5.2 Advisory Agency Responses

**NEW ACLAND COAL MINE
STAGE 3 PROJECT**

**Figure 5.2-R - Water Quality
Sample Sites**

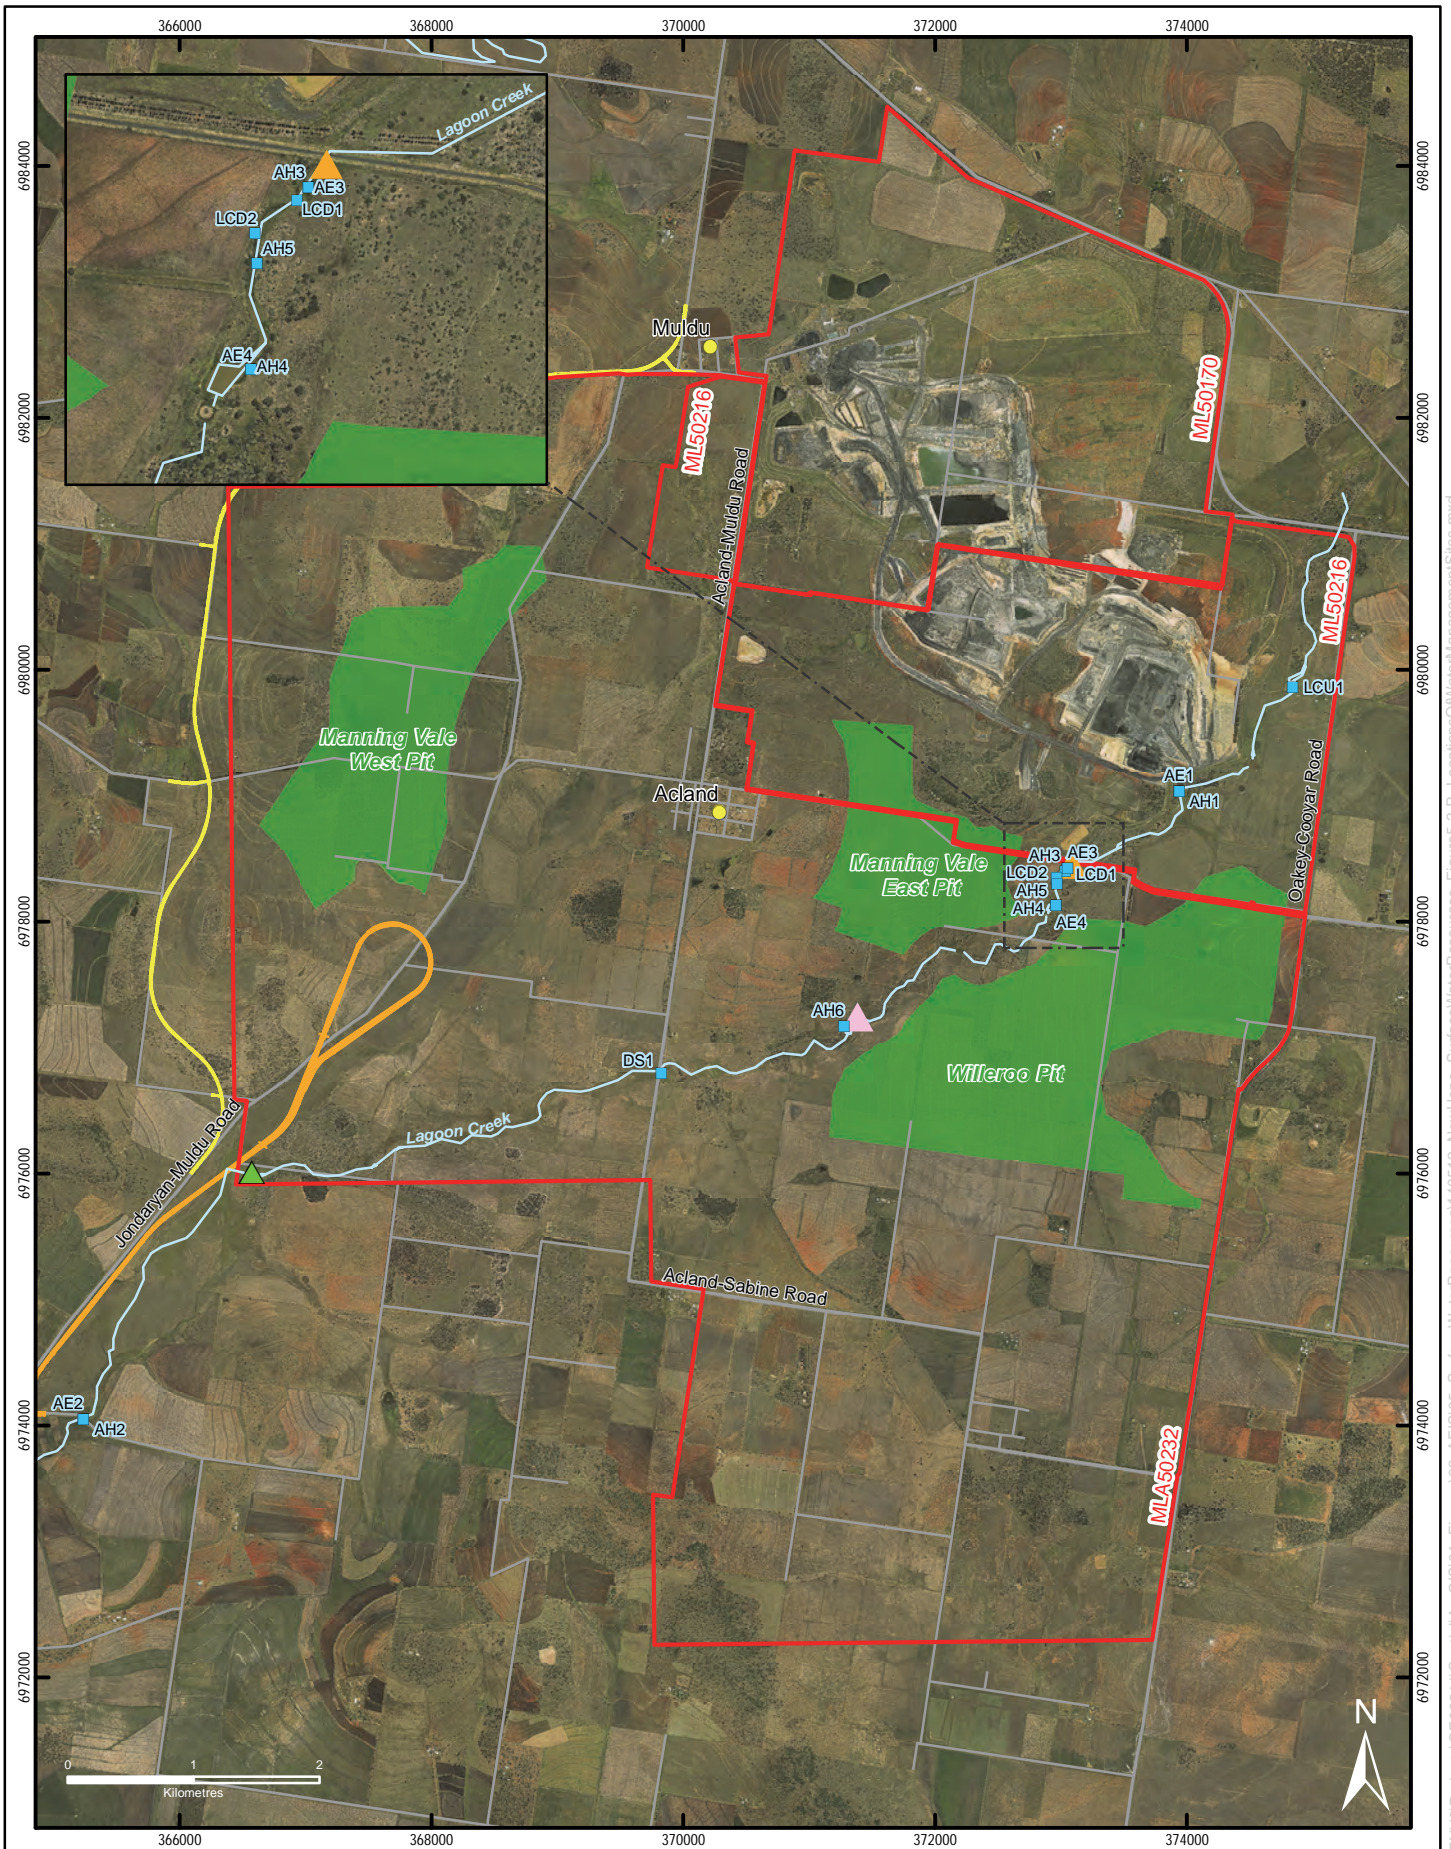
Figure 2-1 of **Appendix J.4** of the draft EIS has been updated to illustrate the location of current mine discharge points, water quality monitoring sites and a proposed compliance point. The location of such sites will be further refined in consultation with DEHP during the development of the REMP. The location of monitoring sites has also been checked with site descriptions in the draft EIS, with corrected locations illustrated in **Figure 5.2-Q**. Site AE2 is the same as Site AH2, Site AE1 is the same as Site AH1, Site AE4 is the same as Site AH4 and Site AE5 is the same as Site AH5.

Currently the mine discharges from ED1, ED2, ED 3 and ED4. However, historically only ED3 and ED 1 have been required to discharge. The location of these storages is located on **Figure 5.2-R**. NHG

will consult with DEHP regarding any proposed refinement of monitoring sites, to provide further confidence that they are fit for purpose.

Figure 5.2-S Annual Controlled Release Volume

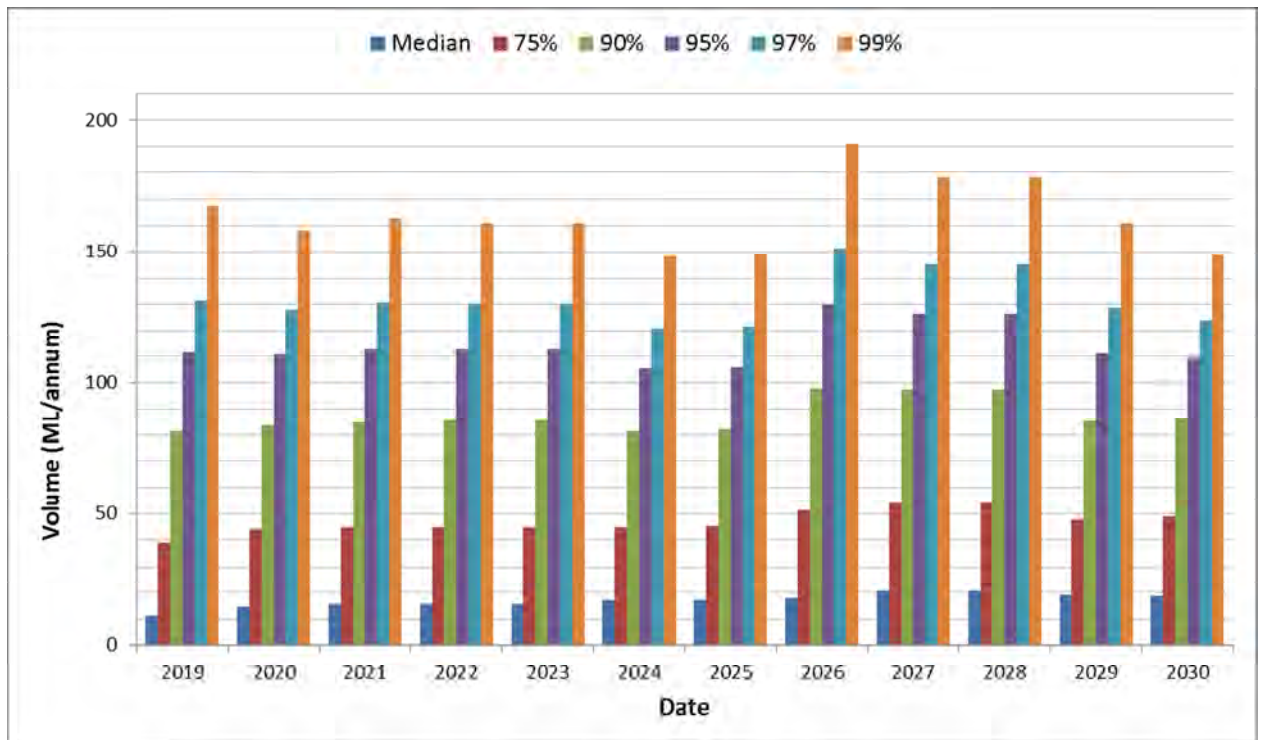
It is noted that the annual controlled release volume presented in **Figure 5-35** of the draft EIS and **Figure 5-3** of the Water Management Plan - **Appendix J.4** presents the total volume predicted to be released over a given year. That is at the 99th percentile of the probabilistic rainfall (very wet year) there is predicted to be 190 ML released in the year 2026. An updated chart is provided in **Figure 5.2-S** below.

As per the above comment it is noted that there is a typographical error in the second sentence of the first paragraph on page 80 of **Chapter 5** and the sentence should read. *“The results indicate that in an average year only minor releases in the order of 20 ML/year will be made to Lagoon Creek with releases increasing to a maximum of 170 ML/year in the 1 % exceedance probability (very wet year).”*

Figure 5.2-V Predicted Mine Pit Inflows (median value plus one standard deviation either side)

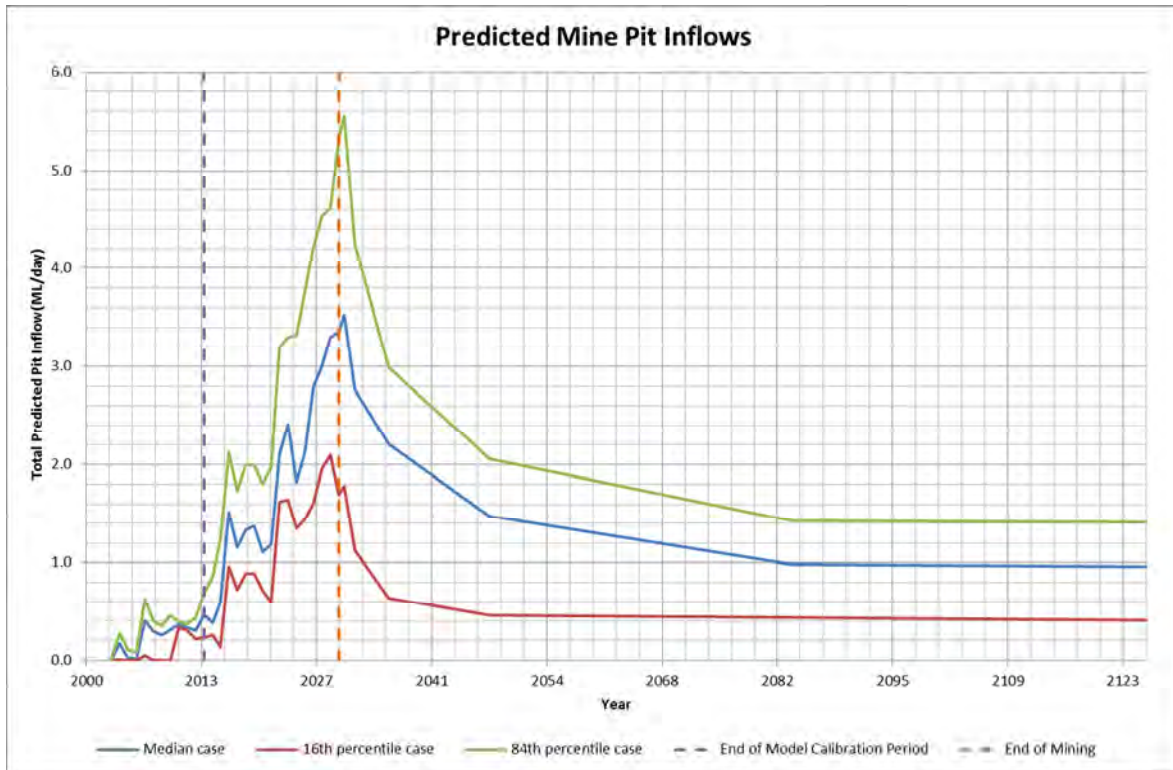
The updated predicted groundwater inflows to the revised Project's mining pits are shown in **Figure 5.2-V**. Inflows gradually increase during mining before peaking immediately prior to the completion of the mining phase (2030) at approximately 3.5 ML/day (median case), which will be spread variably across the three operational pits. The general increase in groundwater inflows to the revised Project's mining pits during mining is a result of mining depths generally becoming greater as the revised Project progresses, especially in the Willeroo Pit. The peak in the predicted inflow curve in the latter stages of mining is a result of an increased mining area being simulated. The increase in mining area is associated with the mine plans going from 2 year increments to a 3 year block at the end of mining. It is expected that actual inflows would be less than modelled, with a smooth inflow curve consistent with the progressive nature of mining. The updated model predictions result in peak median predicted inflows to the revised Project's pits of around 3.5 ML/day close to the end of mining, compared to 3.8 ML/day in the previous model as reported in the draft EIS. Overall, this change is not considered significant.

The uncertainty of inflow predictions, as indicated by the upper and lower bounds (16th and 84th percentiles, equivalent to one standard deviation), is relatively small (< +/- 20% the median). The inflows account for evaporation at the time of seepage from the groundwater system but do not account for any evaporation while in the water management system (ponds, sumps etc.).
